Access Compliance Report

Public Rights-of-Way

(Curb Ramps)

Intersection ID: 24455	Main Street: S_TRYON_ST	Cross Street: STEELE_CREEK_RD	Location: SE
ADA ID: 9A55C73315C1	Ramp Type: Perp	Initial Pass/Fail: Fail	Overall Compliance: No
			Severity Score: 21.25

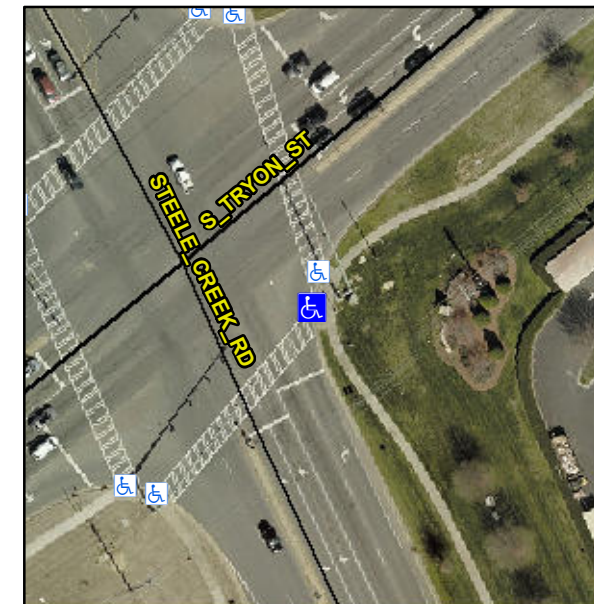
R304.5.1, R304.2.2

Compliance	Description	Data	Compliance	Description	Data
N/A	Ramp Length (in)	48.0	No	Ramp Slope (%)	8.9
No	Ramp Width (in)	46.0	Yes	Ramp XSlope (%)	1.3
N/A	Flare Type LT	N/A	N/A	Flare Type RT	N/A
N/A	Flare Slope LT (%)	N/A	N/A	Flare Slope RT (%)	N/A
N/A	Flare Traversable LT?	N/A	N/A	Flare Traversable RT?	N/A
N/A	Landing Length (in)	N/A	N/A	DWS Provided?	N/A
N/A	Landing Width (in)	N/A	N/A	DWS Contrast?	N/A
N/A	Landing Slope (%)	N/A	N/A	DWS Length (in)	N/A
N/A	Landing X Slope (%)	N/A	N/A	DWS Full Width?	N/A
N/A	Landing Curb? (Y/N)	N/A	N/A	DWS Offset (in)	N/A
N/A	Shared Landing?	N/A			
N/A	Gutter Ponding?	N/A	N/A	Gutter Slope (%)	N/A
N/A	Gutter Lip Ht (in)	N/A	N/A	Gutter X Slope (%)	N/A
N/A	Painted X Walk1?	Yes	N/A	Painted X Walk2?	N/A
	X Walk 1 Direction	To SW		X Walk 2 Direction	N/A
N/A	X Walk 1 Width (in)	120.0	N/A	X Walk 2 Width (in)	N/A
	X Walk 1 Slope (%)	2.7		X Walk 2 Slope (%)	N/A
	X Walk 1 X Slope (%)	1.4		X Walk 2 X Slope (%)	N/A

Remove & Replace Entire Ramp.
